NUMBER: 85-6

- A. Power Trim Pump 20 Amp Fuse Blowing on MerCruiser 120-thru-300 R & MR Models
- B. MC-I Gear Housing Shimming Tool, 91-56048
- C. MC-I Gear Housing Reverse Gear, 43-61026

Figure 1. Trim Limit Switch Leads Shorting Out

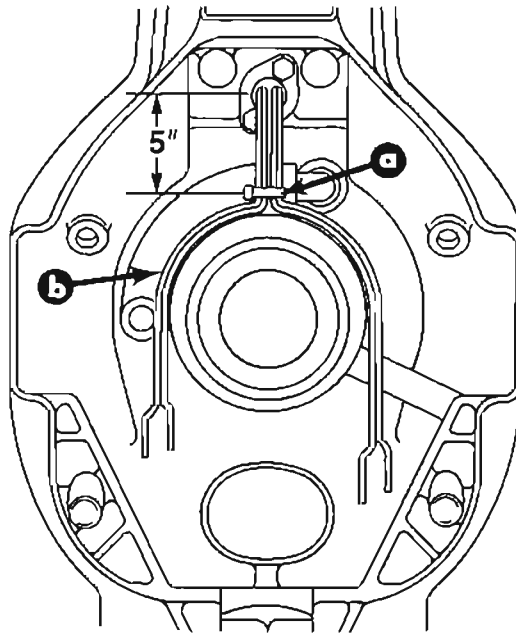
If you encounter a MerCruiser 120-thru-300 R & MR model that blows the 20 amp fuse on the Power Trim pump when trimming "Out/Up", problem may be due to the trim limit switch leads shorting out. We have received reports where the insulation on the leads has chafed thru and allowed the conductor to come in contact with the gimbal housing, causing the shorting condition. (Figure 1)

a - Leads Chafe Thru and Short Out In This Area

To correct this condition, install new trim limit switch and lead assembly 99122A2 and route leads as shown in Figure 2.

- a - Sta-Strap 61990
- b - Route Leads on Front Side of Hose (As Viewed From Rear)

MerCruiser 120MR-thru-300MR models with transom assembly serial number 0A354131 and above will have the trim limit switch leads re-routed from the factory.

New routing method should be used whenever servicing any MerCruiser I model with trim limit switch on side of gimbal ring.

Figure 3. Shimming Tool, 91-56048

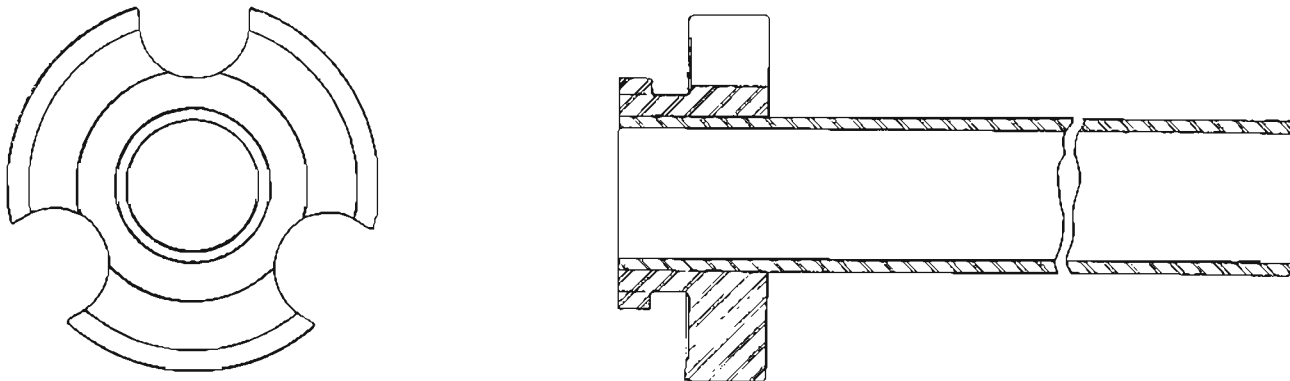
Shimming Tool, 91-56048 has been changed to incorporate 3 shimming locations. (Figure 3) The 3 locations are identical and any one of the three may be used. Change was made to extend tool life. Part number will not be changed.
